**Regular Meeting of the Planning Commission**

**ITEM DESCRIPTION: ZONING CASE 23-07: SITE PLAN STRACK  
CONSTRUCTION FOR C&L DISTRIBUTION LOCATED  
NORTHWEST OF HIGHWAY 33 AND STARK ROAD**

### MEMO

**SUBJECT:** C & L Distributing - Grading permit application review

DRAWING NO.  
**C-4**  
REV. NO.  
**0**

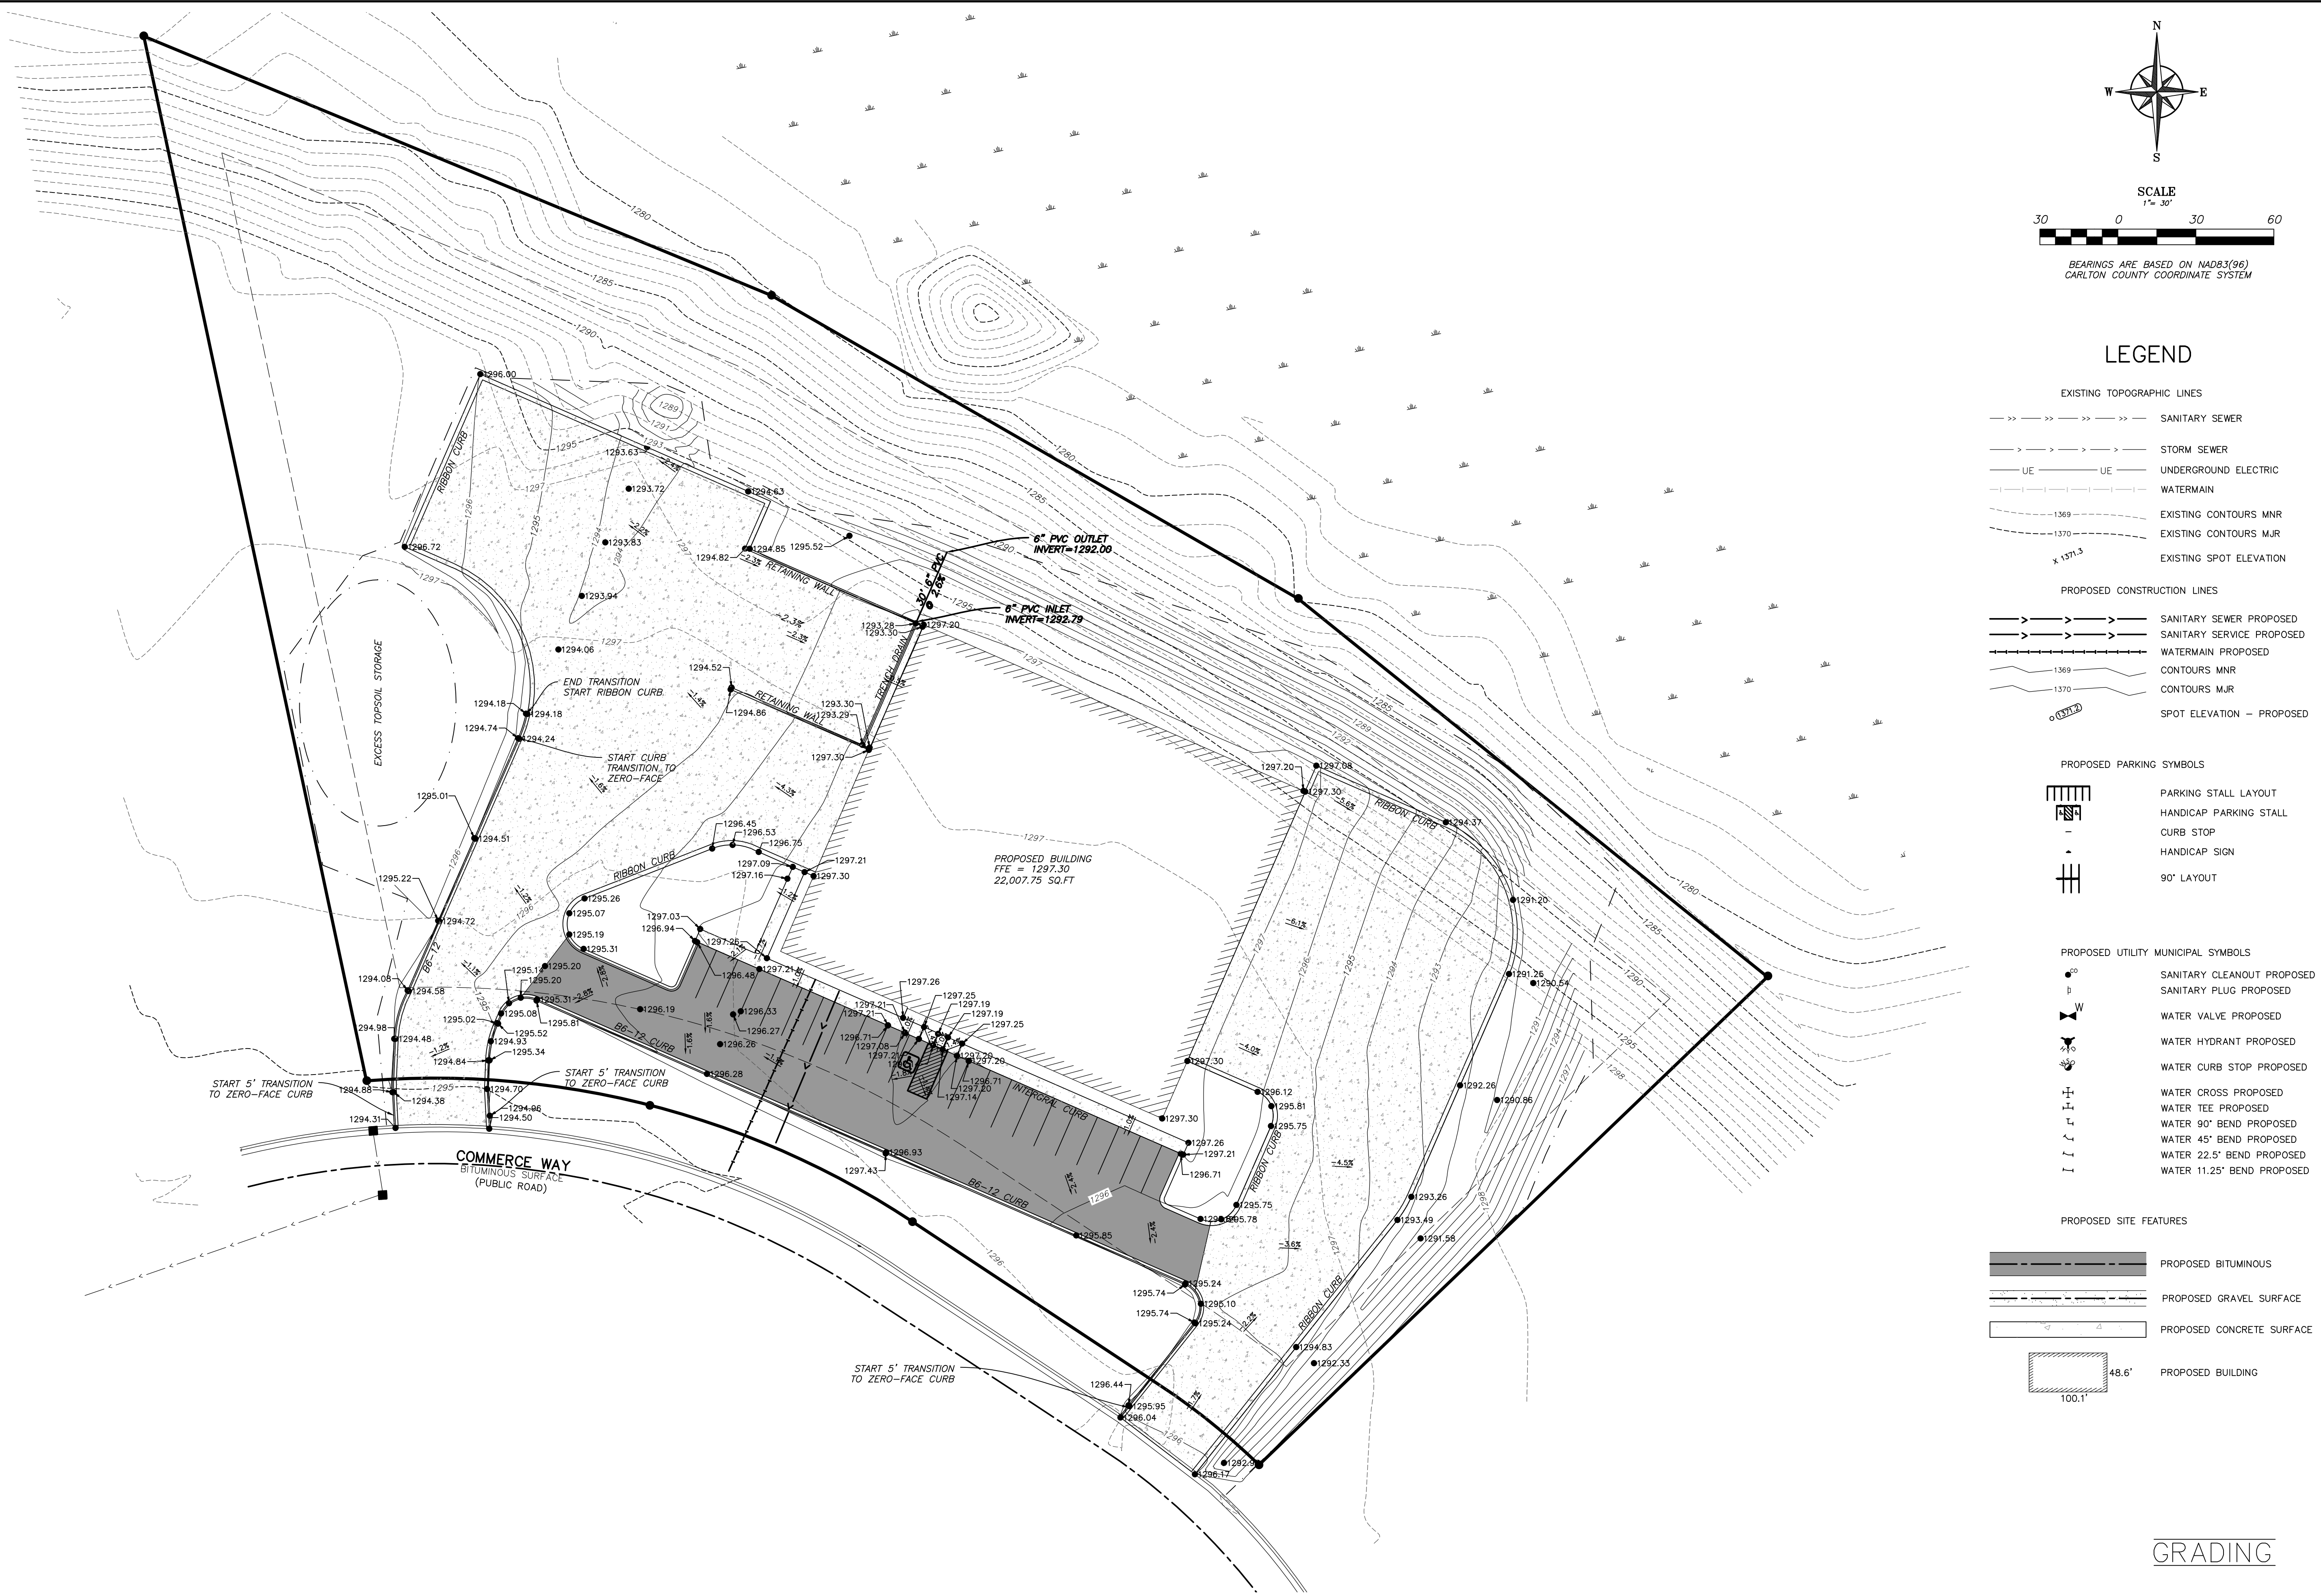
15. The driveway on the easterly end of the site is situated about 20 feet from the easterly property line. There is a fire hydrant located about 15 feet to the east of this driveway and less than 1 foot behind the curb. This hydrant is vulnerable to being hit by semi-trucks that cut the corner of the driveway. The site would allow for this driveway to move 20 feet to the west to provide a little more clearance from this hydrant.
16. The driveway openings do not show removing the surmountable curb and replacing it with a concrete apron. The ride as you enter the driveway is a little rougher if the surmountable curb is left in place. This decision is left to the owner and designer. If you plan to leave the curb in place, consider placing tapers or radii on the last 5 to 10 feet of new curb adjacent to the street curb.

DRAWING NO.  
**C-5**  
REV. NO.  
**0**

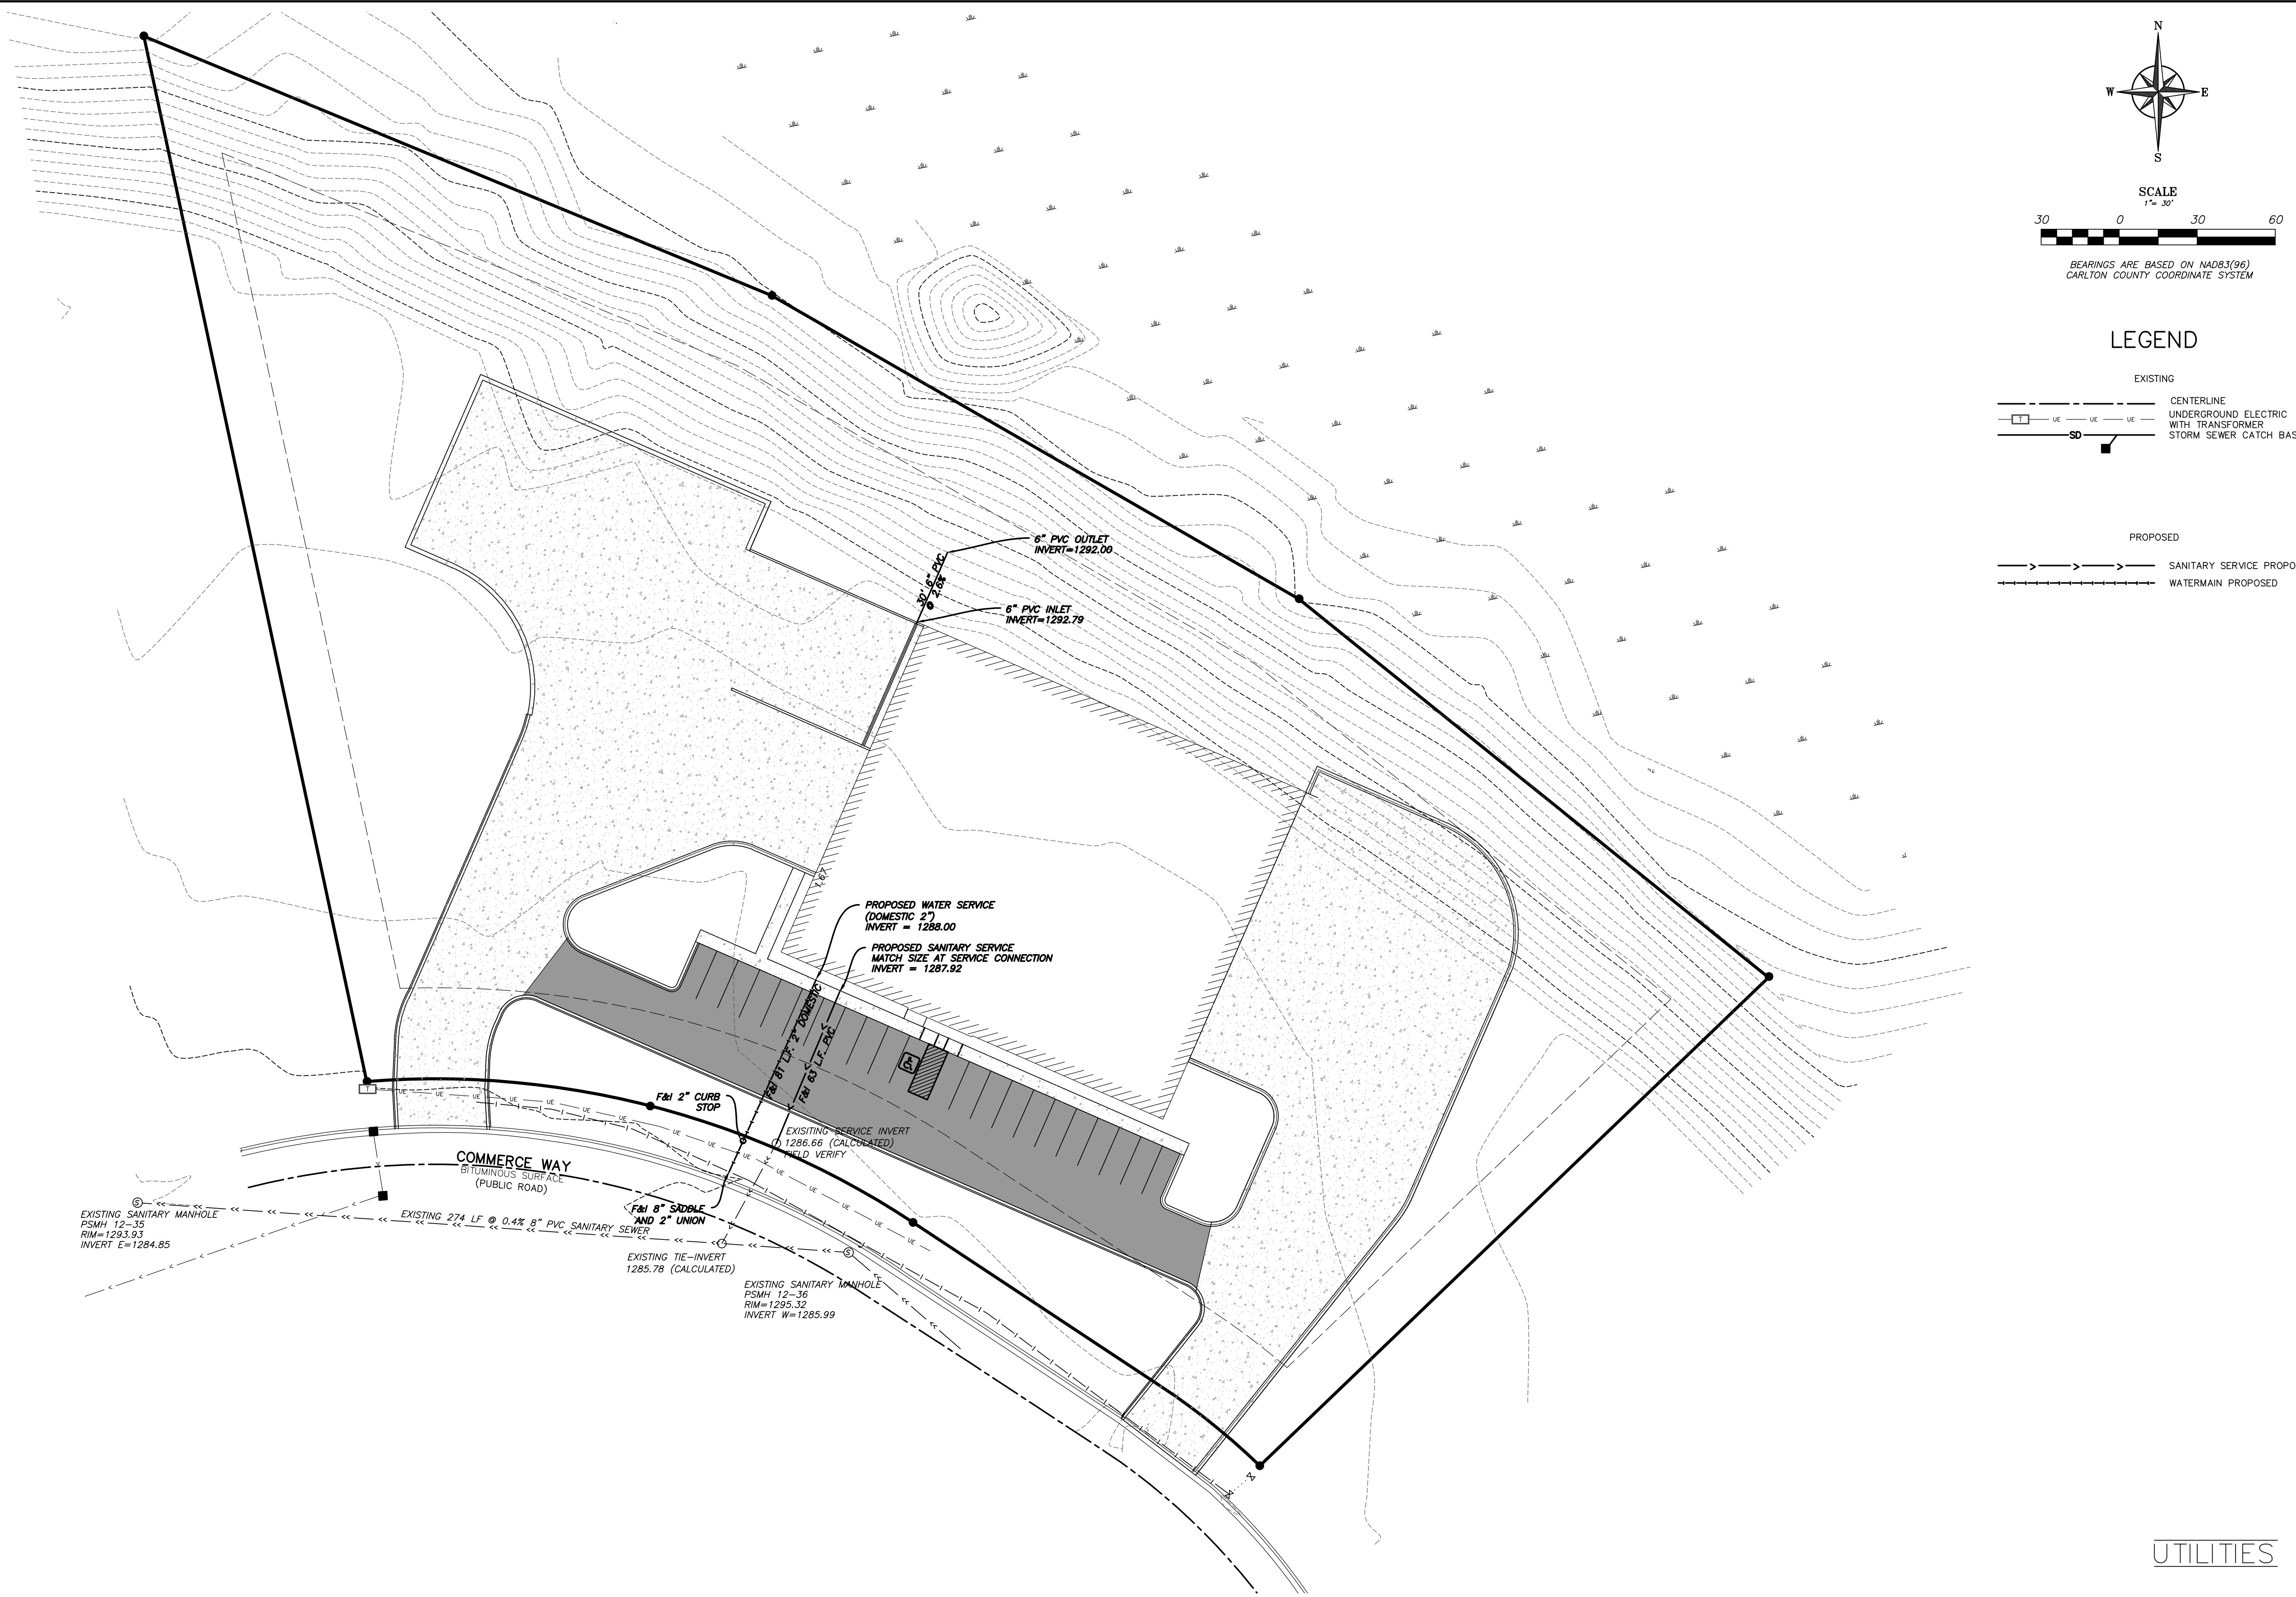
17. The grade in the bottom of the swale along the east property line is less than 1% which is the minimum grade allowed in grass swales.
18. The swale along the east property line extends into the ROW of Commerce Drive. The grade behind the Curb of Commerce Way should remain flat with a slight slope towards the curb of Commerce Way.

19. The grading between the parking lot and the existing gravel trail at the North east end of the parking lot places fill on the trail and makes the slope exceed 3:1. The trail grade cannot be disturbed and the slope cannot exceed 3:1.
20. Drainage is discharged down the north slope at two concentrated locations and at the bottom of the slope this drainage crosses the existing gravel trail. This drainage must not cross over the trail but must be conveyed by pipe under the trail.
